MONTGOMERY COUNTY HISTORIC PRESERVATION COMMISSION
STAFF REPORT

Address:	7338 Carroll Ave., Takoma Park	Meeting Date:	7/12/2023
Resource:	Contributing Resource Takoma Park Historic District	Report Date:	7/5/2023
Applicant:	David Heath & Nadine Langlois Brian McCarthy, Architect	Public Notice:	6/28/2023
Review:	Historic Area Work Permit	Tax Credit:	Partial
Permit No.:	1034991	Staff:	Dan Bruechert
Proposal:	For partial demolition, construction of new rear addition, deck, and screened-in porch, roof and gutter replacement, and fenestration alterations.

STAFF RECOMMENDATION

DEMOLITION ELEVATIONS

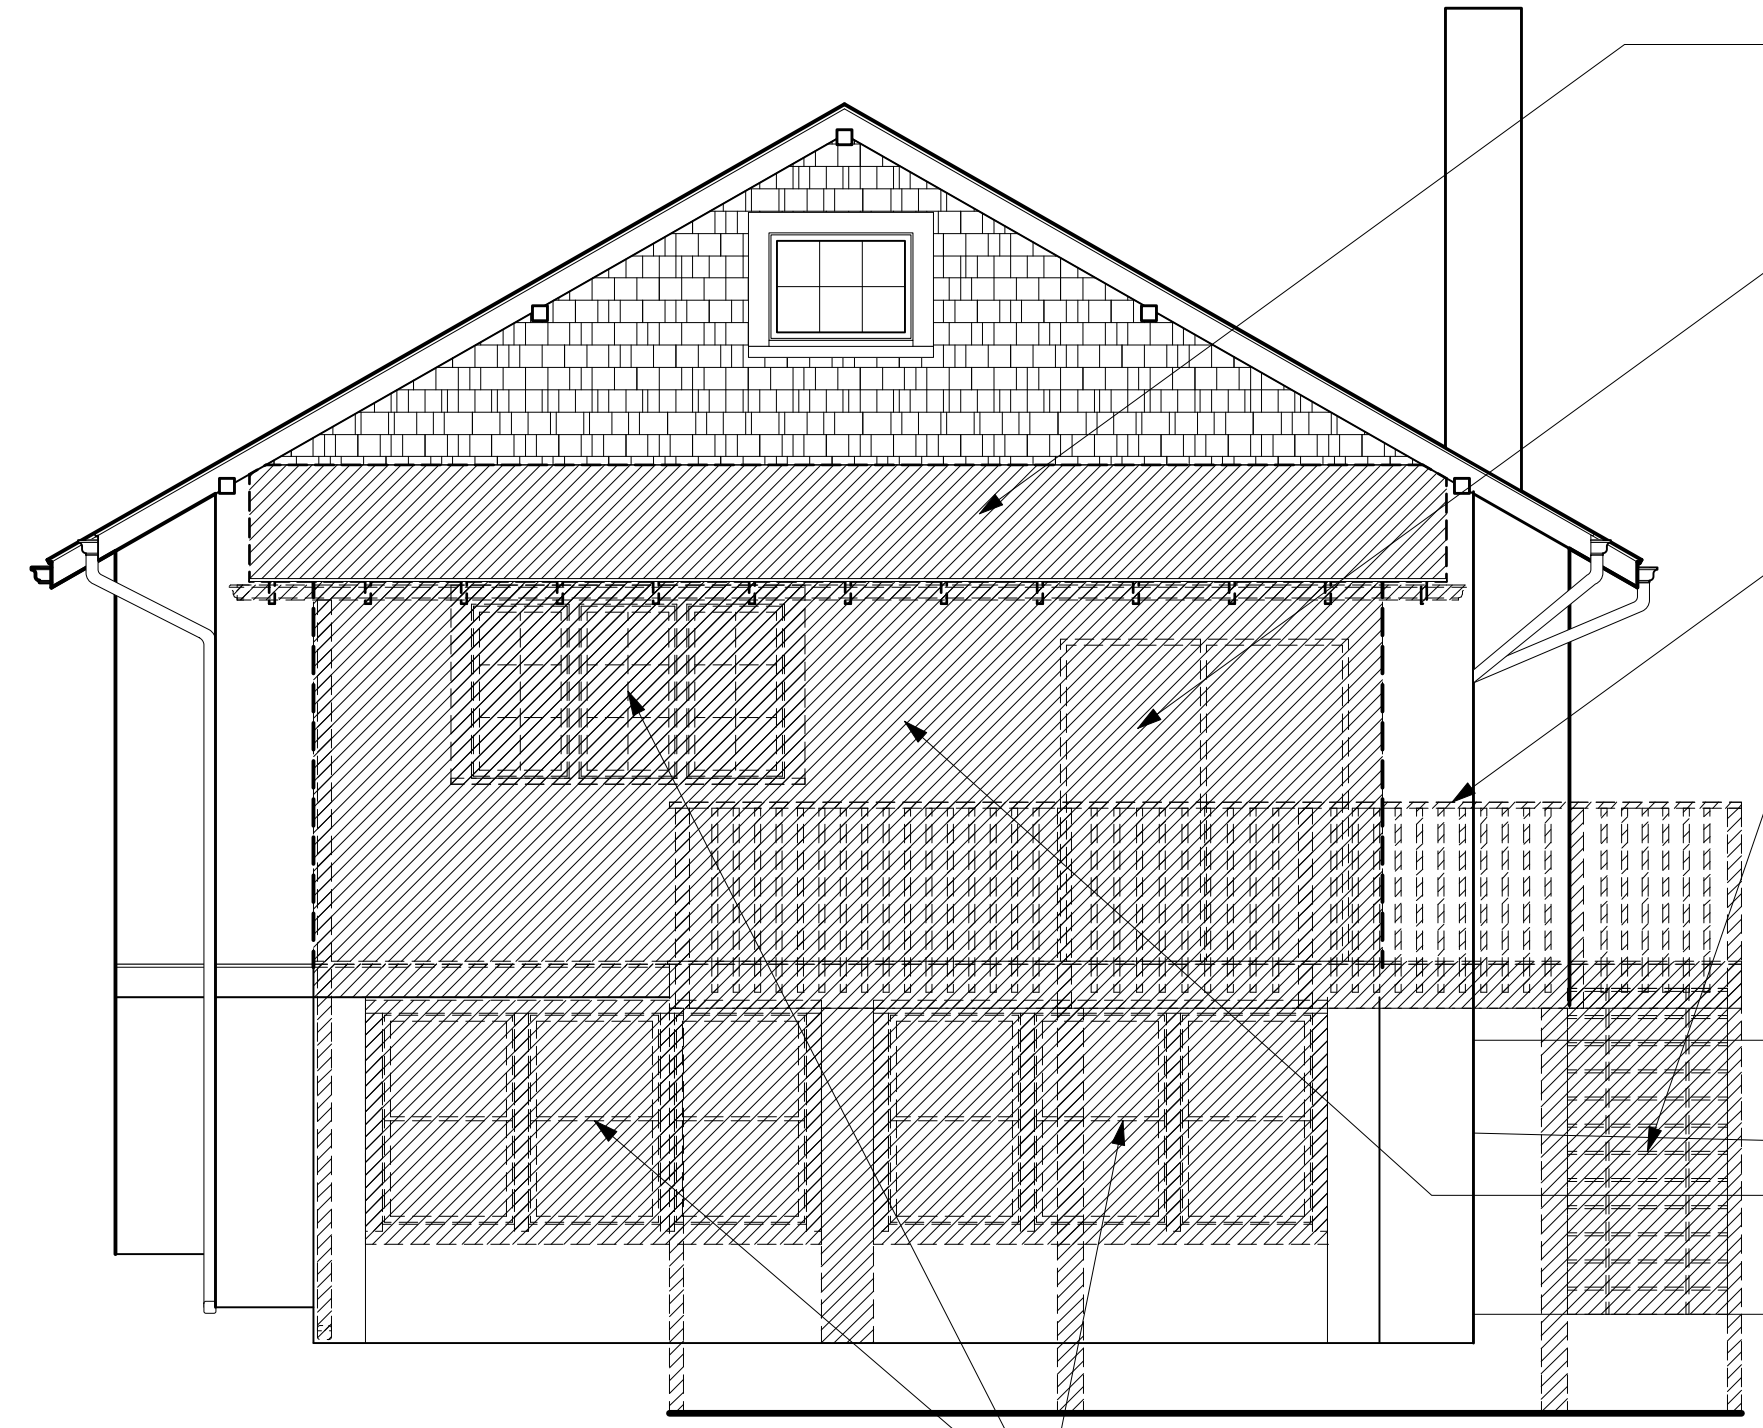
The applicant proposes to demolish the rear (west) and left (south) walls of the non-historic addition and proposes to demolish the existing wood deck to accommodate the proposed addition (discussed below).

Staff finds the proposed work will not impact historic materials or impact the historic house design and will not be visible from the public right-of-way. The *Design Guidelines* state this type of change should be approved as a matter of course. Staff also finds support for the proposed demolition in 24A-8(d).

ELEVATIONS

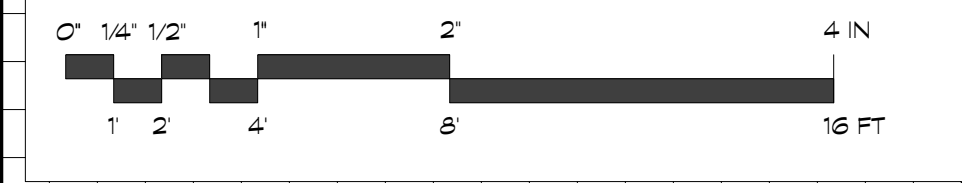
- 1) The final drawings shall show all dimensions in plans and elevations, including measurements for any details for finished carpentry work in the gable ends; and,
- 2) The fiber cement siding on the addition shall have a smooth profile.

At the rear of the house, the applicant proposes to construct a two-story addition to accommodate two bedrooms on the basement level and a new bedroom suite on the first floor. The addition also includes construction of a first-floor screened-in porch. The proposed addition utilizes the existing inset created by non-historic addition to separate the new construction from the historic. The addition measures 25' 11 5/8" × 14' 4 1/2" (twenty-five feet, eleven and five-eighths inches wide by fourteen feet four-and-one-half inch deep); with the screened-in porch projecting an additional 10' (ten feet) to the left (south) of the proposed addition extending beyond the historic wall plane. The roof over the addition is a side gable to run perpendicular to the historic front-facing gable. While the elevation drawings lack measurements, they show that the proposed side-gable roof is at least two feet lower than the front-gable ridge. Eaves, rakes, and brackets on the proposed addition will match those found on the historic portion of the house. Staff recommends the HPC include a condition for the final approval of this HAWP that all drawings submitted for permitting will be annotated to include all necessary measurements. Final approval authority to ensure conformance with this condition can be delegated to Staff.

The addition will be sided with a parged CMU block foundation, fiber cement clapboards, and cedar shingles in the gable. Windows for the addition will be Weathershield clad casement and sash windows. Because the windows on the rear elevation are in bedrooms and need to satisfy egress code, the windows on the rear elevation will be casement windows with a six-over-one appearance with a check rail to mimic the appearance of a sash meeting rail. The roof on the addition will be an architectural shingle roof to match the replacement on the historic portion of the house (discussed below). Finally, the applicant proposes to use Aeratis porch decking treads and railing.

Staff finds the overall size of the addition to be modest and that it will not overwhelm the historic house or the surrounding district. Staff finds the form and architectural details of the proposed addition to be compatible with the simple shape of the historic Craftsman bungalow. It also matches many of the details including the parged foundation, eave treatment, and six-over-one windows. Generally, additions in the Takoma Park Historic District are required to be placed to the rear of the historic house so they are less visible from the right-of-way and do not visually detract from the historic house and streetscape. This proposed addition projects approximately 1' (one foot) beyond the historic left (south) wall plane with the screened-in porch projecting an additional 10' (ten feet). In this instance, Staff finds the projections will not negatively impact the character of the house. First, the retained portion of the non-historic addition creates a 7' (seven foot) deep hyphen to separate the historic from the new construction. This separation is a big enough visual division that the two larger sections of construction appear as discrete units. Second, the addition is still inset from the plane created by the projecting bay in the existing dining room. Third, while the side gable roof adds mass to the screened-in porch, the simple wood framing and screening will make the porch appear largely transparent. For these reasons, Staff finds the size, form, placement and architectural details to be appropriate for the subject property under 24A-8(b)(2) and (d), the *Design Guidelines*, and Standard 9.

Staff finds the proposed materials including the fiber cement siding, clad wood windows, and architectural shingle roof are all compatible with the character of the house and are appropriate substitute materials for additions and new construction in the Takoma Park Historic District under the *Design Guidelines* and 24A-8(d). Staff also finds the fiber cement siding will help differentiate the addition from the historic construction per Standard 9, provided the smooth profile of the fiber cement siding is exposed. Because an installation treatment for the fiber cement siding was not included with the application materials, Staff recommends the HPC include a condition to the approval of this HAWP that the smooth side of the fiber cement is exposed. Final approval authority to verify this condition has been satisfied can be delegated to Staff. The Aeratis decking and railing are the only materials proposed that do not have a long-established track record in the Takoma Park Historic District. Staff finds, in this instance, that Aeratis is appropriate because it is connected to the new construction and will not impact historic fabric. Additionally, the new exterior stairs are more than 50' (fifty feet) from the public right-of-way, a distance that will minimize the material's visual impact. Staff finds the Aeratis decking and railing is appropriate under 24A-8(d) and Standard 9.
